# ADDENDUM COMPLEMENTARY

## EIA Espejo de Tarapacá

### Region of Tarapacá Chile

This document corresponds to the complementary project addendum "**Espejo de Tarapacá**" entered on August 11, 2014 before the service through a study of environmental impact assessment Environmental assessment of the region of Tarapacá.

**Figure 1-2: Cross-sectional diagram of belt conveyor type.**

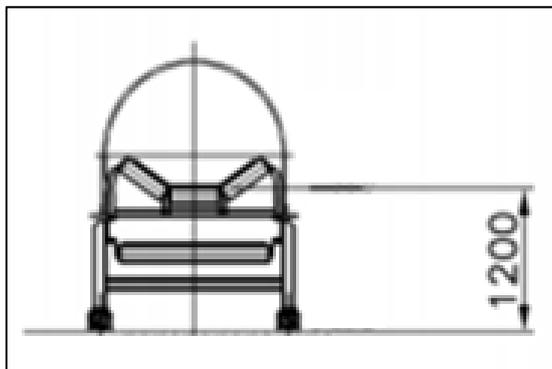
**1.6. In relation to annex 1. 2 plant, of the addendum N ° 1, regarding the Plan to control emissions, and without prejudice as provided, namely, moistening of the roads, trucks, installation of mesh windbreaker bodywork, seal installation of mesh Rachel and maintenance of machinery, the owner must present the measures of engineering or design for the case of arid mailbox and the conveyor belt, since they are the areas where emission of material occurs particulate by the shedding of material from the trucks to the mailbox and in the transport of material in belt conveyor and its later emptied into hopper.**

In regard to the load on the conveyor belt of aggregates for mixing with cement, is proposed as commitment to voluntary use of folding covers or equivalent that seal, to avoid the dispersion of dust to the atmosphere When you perform the. A cross-sectional design type It is shown in the following figure. This will be adapted to the standard measure of thes Plants of concrete and the needs of the project.

**Figure 1-6: Location Miradores tour.**

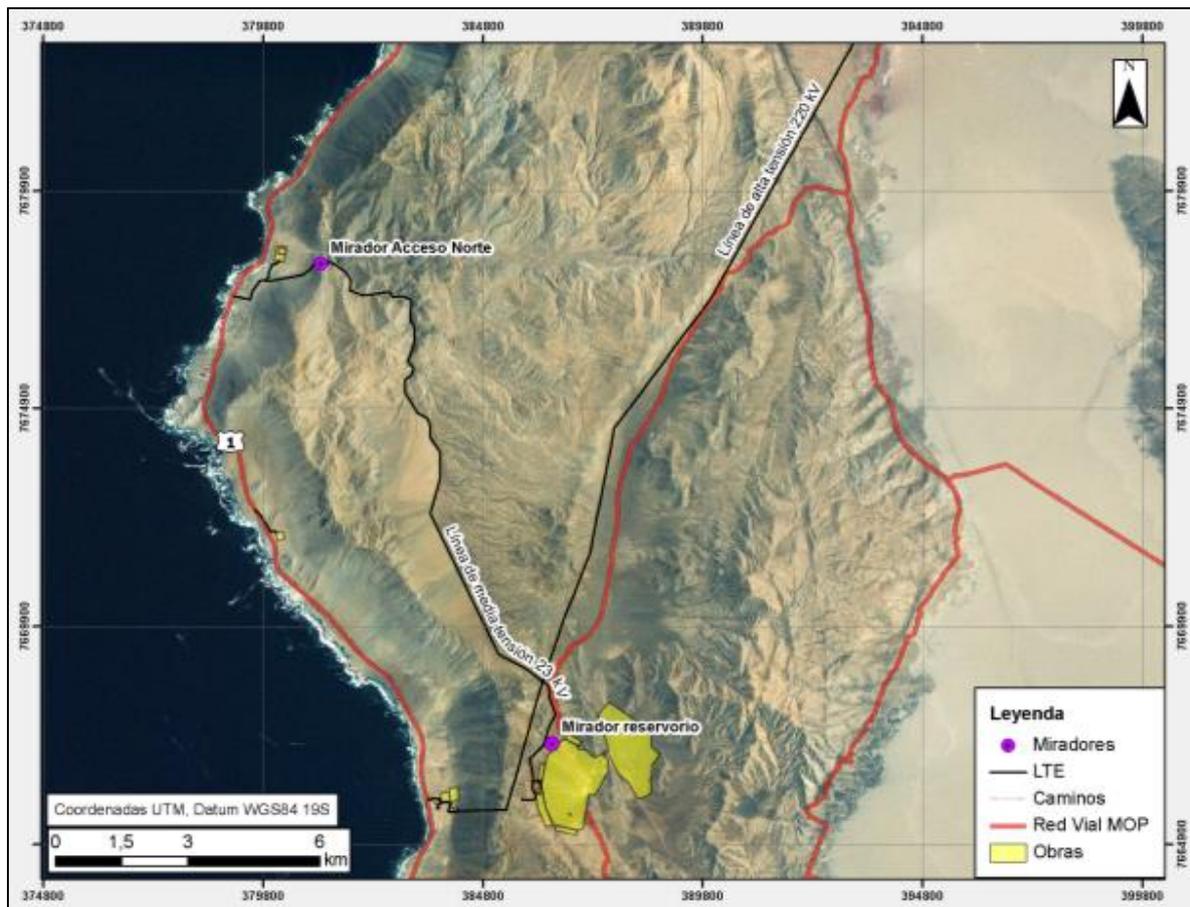
**1.8. In relation to the implementation of tourist lookouts, and which would be validated by the respective municipality and the Regional Directorate of tourism, prior to installation, the holder must declare in detail the form that has been planned the movement of persons in the area of the reservoir, by specifying maximum daily load, type of movement (free or guided), security measures for visitors, In addition to all the background information allowing this measure to evaluate and verify the educational or tourist use posed by the holder.**

Chapter 15 of the EIA "Commitments volunteers", in accordance with 15.2.3 point clarifies tourism in its table 15.5 installation of tourist lookouts that, Once approved by the entities that the authority has provided in this question, i.e., the municipality of Iquique and the Regional direction of SERNATUR, installed two observation points to be used as tourist lookouts (see

Table 1-9)one overlooking the reservoir and the other in the sector of the Northern access view road to the sea, as shown in the following figure.

Figure 3-4: The project Area for Regional Geology.

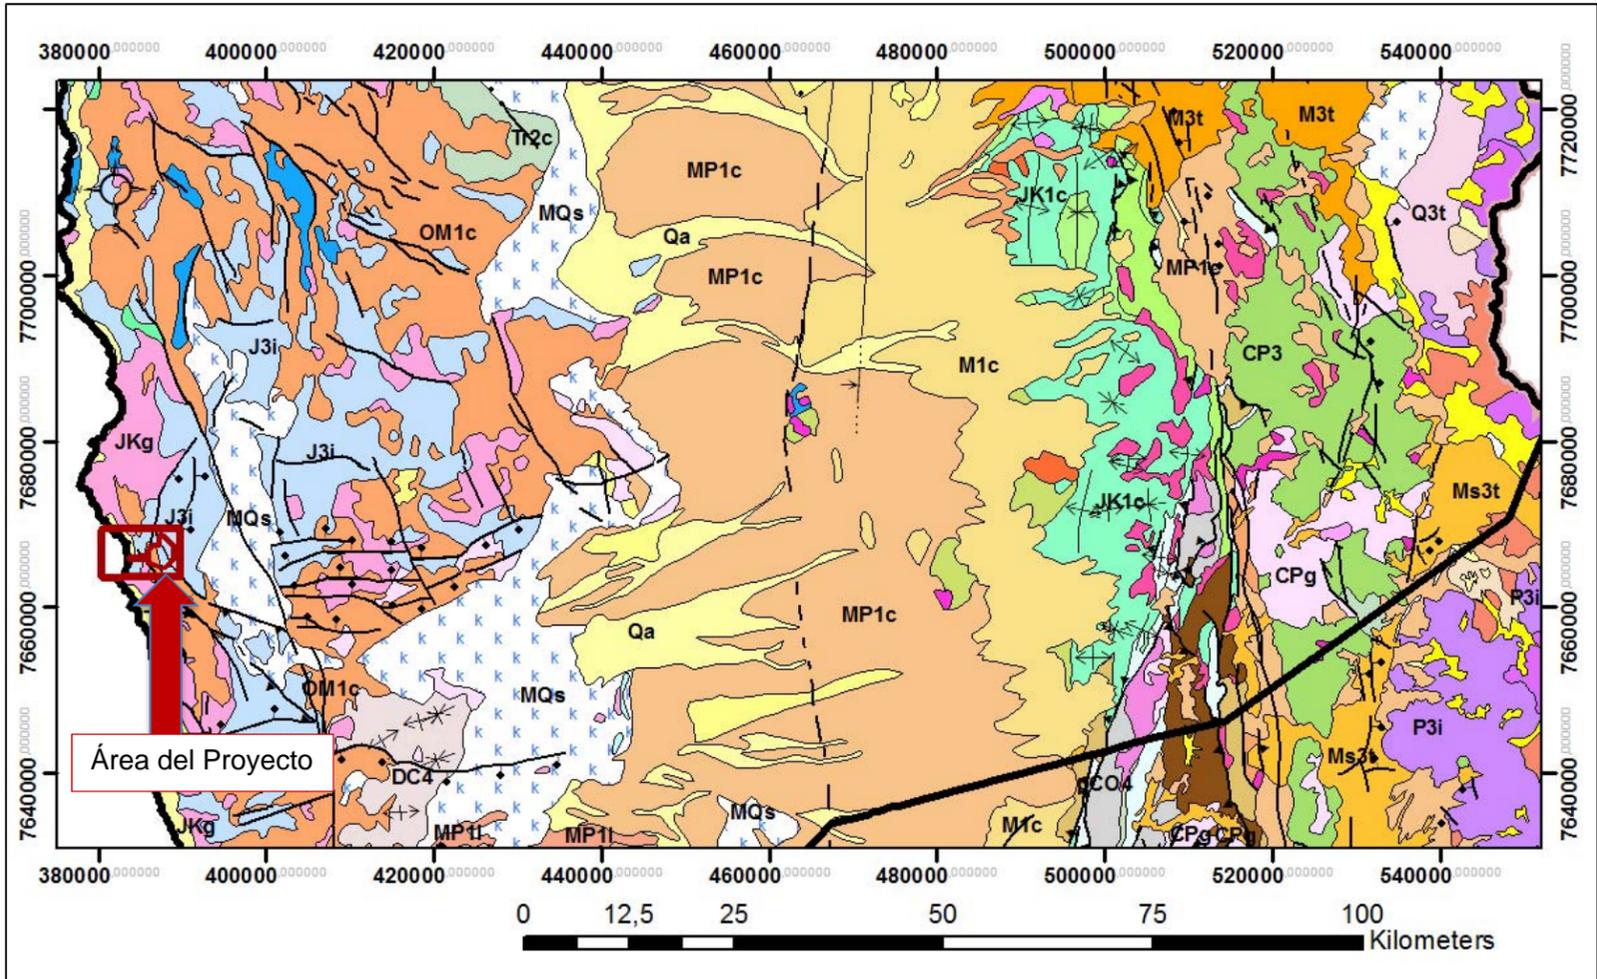
- 3.3.1. Geology and structures:** there is a description of the geology at the regional level. On the other hand, in point 2.2, local geology refers to the Deputy level "Geology Area priority South Patache – plant and profile Longitudinal", which is not attached.
- 3.3.2. Geotechnical studies:** there is the lithological description of drilled wells, included only the permeability tests conducted on them. Also, the information presented shows discrepancies, as is concludes the study Geophysicist filling

In the concerning the regional geology above mentioned information is presented from p. 43 to 56 of Chapter 3 the EIA, including among others, Figure 3-30 with the regional geology according to the geological map of Chile scale 1: 1,000,000 SERNAGEOMIN between the parallel 7720000 and 7630000 approximately, which is reproduced below.

**Figure 3-10: Fossiliferous areas (AF1 to AF4) and its contents and fossil point outside the area of influence.**

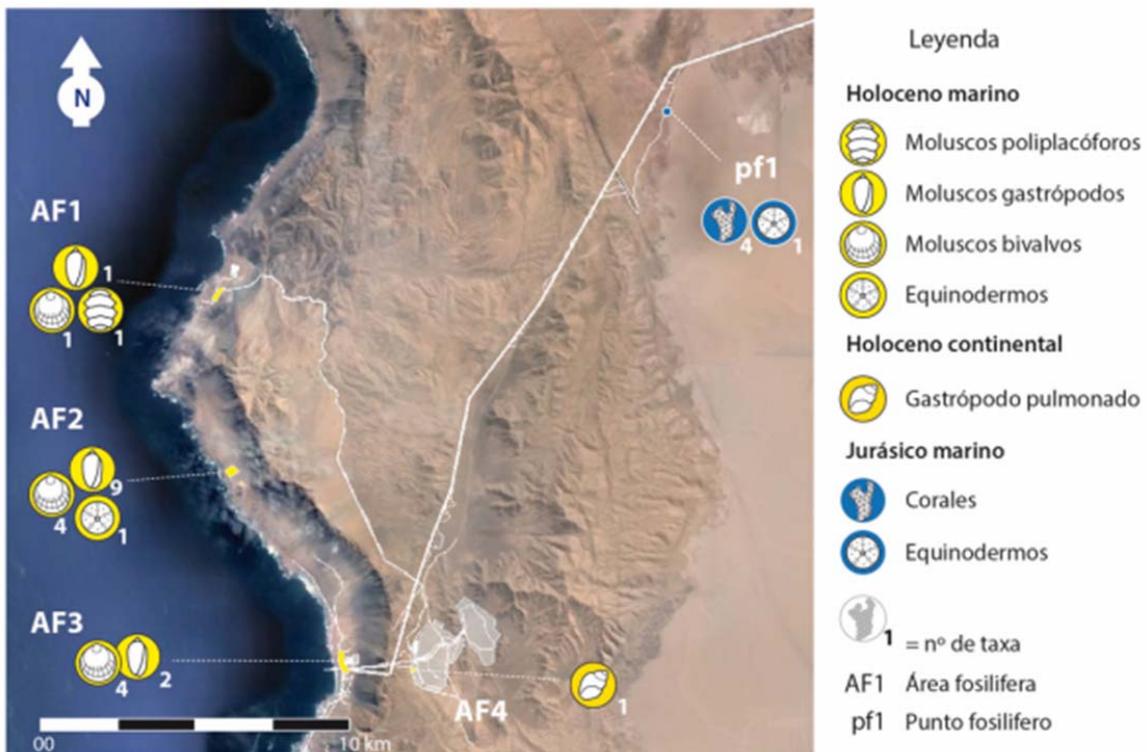
**3.10. With respect to the paleontological component (Annex 3-8 of the addendum 1 of the EIS), the holder must perform and present the analysis of the S2 and S3, drilling that do not appear in table 3-5 (p. 66) of paleontological baseline. This application is based on what was said in comment ICSARA 3.28 N ° 1, which specified the following: "If there were polls they should be mapped and, taking into consideration the limitations of this method, try to establish if the geological materials" described are at least "susceptible" from the point of view of the fossil and/or sedimentological, always taking into account the above-mentioned classification"**

Below is a figure with the fossiliferous areas and its contents According to the findings of the field work that were identified in the area of influence of the project. Also includes the fossil point (pf1) recognized in the vicinity (CA. 500 m) of the project, outside the area of influence.

In the previous figure, you can see that they determined four fossil Areas in the area of the project, three of which are in the coastal sector and correspond to a site de not mineralized fossils of the present in all the coastal sector and the fourth oloceno is located in the area of the reservoir. Included fossil point "pf1" only for effects of contribute to the knowledge puestor that it will not be affected by the project.
